PLAN REVIEW SHEET

2016-084

Quik Trip Corporation

Below is an image of the standard detail (60.01B) for the requested bus stop pad. Permanent easement is requested, where dimensions exceed existing or proposed right-of-way limits.

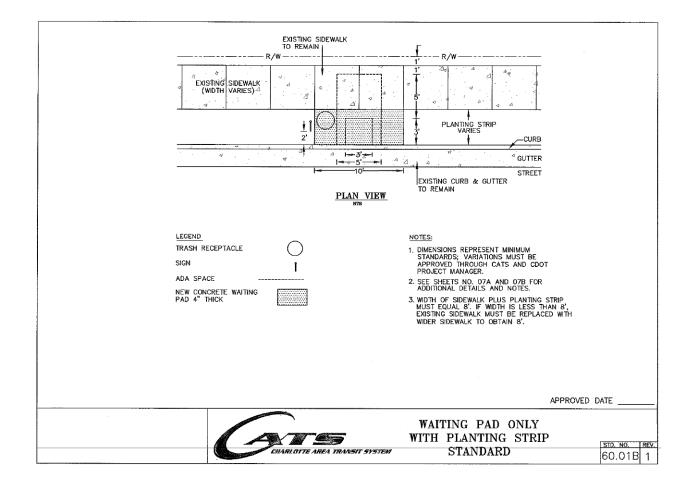
This site is located on an existing bus route. The Petitioner is requested to provide and construct a new waiting pad for the existing bus stop on Brookshire Boulevard, ideally closer to North Cloudman Street than Hoskins Road, in order to minimize traffic impacts.
